Appendix 9.1 Email Consultation with OIC Environmental Health

From: Simon Waddell <simon.waddell@itpenergised.com>
Sent: 22 October 2019 17:07
To: Paul Turner <Paul.turner@orkney.gov.uk>
Cc: Rebecca Todd <rebecca.todd@itpenergised.com>; Roy Ferguson <Roy.Ferguson@itpenergised.com>; Lindsay Smith <Lindsay.Smith@itpenergised.com>; Gregor Massie <Gregor.Massie@itpenergised.com>
Subject: Quanterness wind farm - baseline proxies and adoption of fixed minimum limit - daytime period

Subject: RE: Commercially confidential - Derivation of Quanterness noise limits

Figure 1 – Allocation of representative baseline data to representative NSRs

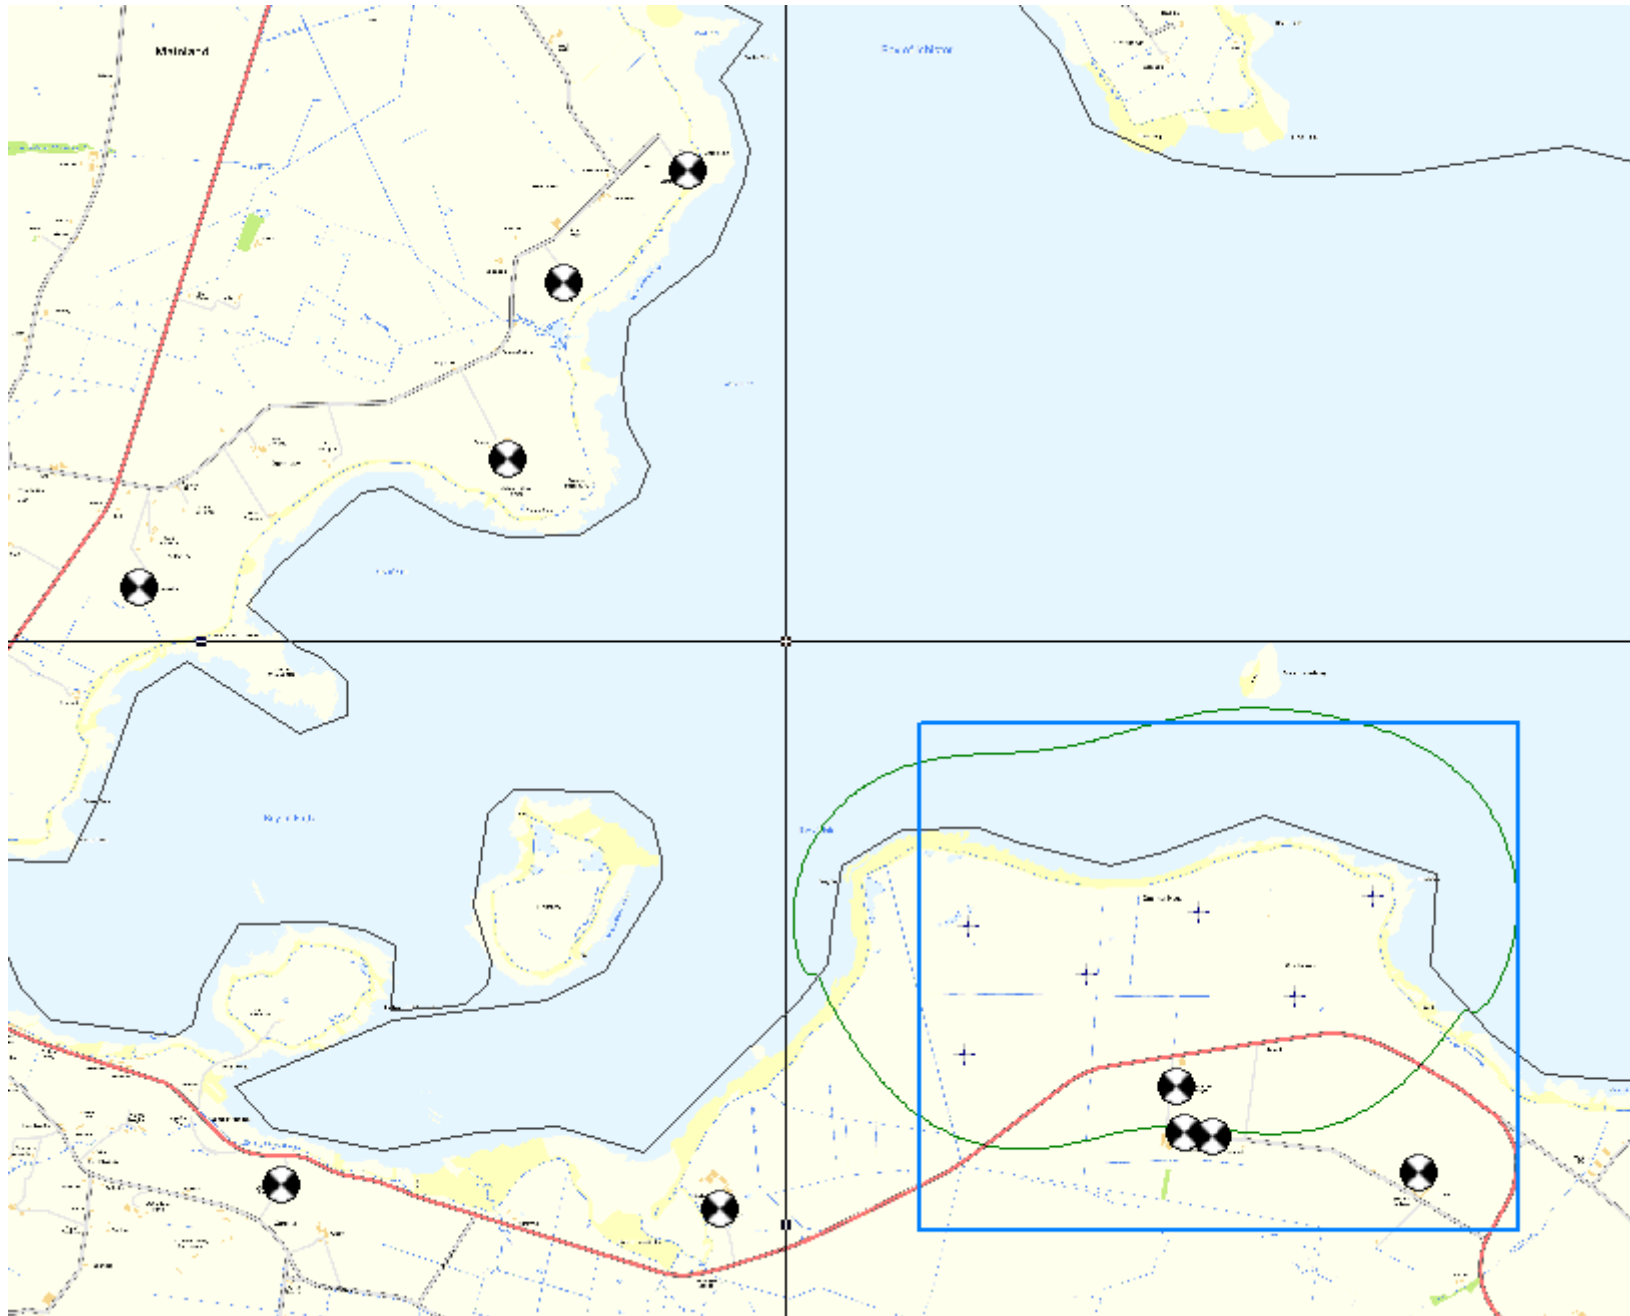
The 35 dBL_{A90} operational noise contour at 9m/s (turbine maximum sound power level) is shown as a green line. – Sorry but I am unsure how you have calculated this 35dB noise contour, do we have a make and model of turbine decided (news to me) or is this just an initial indicative contour based on a “candidate” turbine?

Noise levels at NSRs within the blue box are considered to experience a similar noise environment to Quanterness Farm, where background noise is predominantly affected by the wind. The logic behind this will need to be carefully discussed in the final acoustic report, on a visual assessment you would expect Rennibister/Rennibister Cottage to be within the blue box (controlled by Quanterness Farm levels) and this would be my assumption especially given the proximity of Rennibister properties to the road. My gut feeling is Rennibister and Rossmyre properties should be in within the blue box.

Noise levels at NSRs outside the blue box are considered to experience a similar noise environment to Mou Ness, at which is influenced both by the wind and also noise from the sea. – See above
